REMARKS

DRAWING OBJECTION:

FIG. 1
PRIOR ART

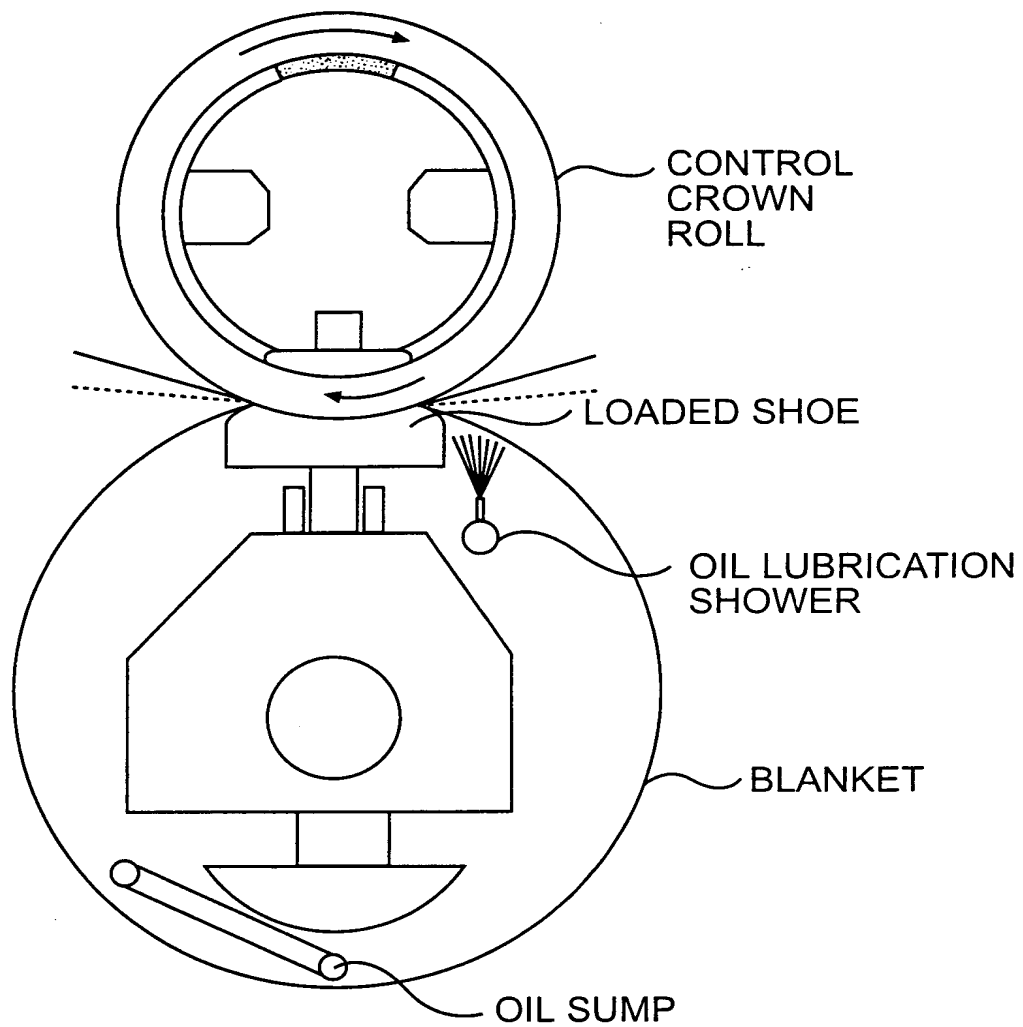
The Examiner has requested that Figures 1, 4, and 5 be designated as prior art. The applicants have submitted the drawing amendments for the Examiner's approval. The applicants will present formal drawings upon indication by the Examiner of his acceptance of the proposed changes.
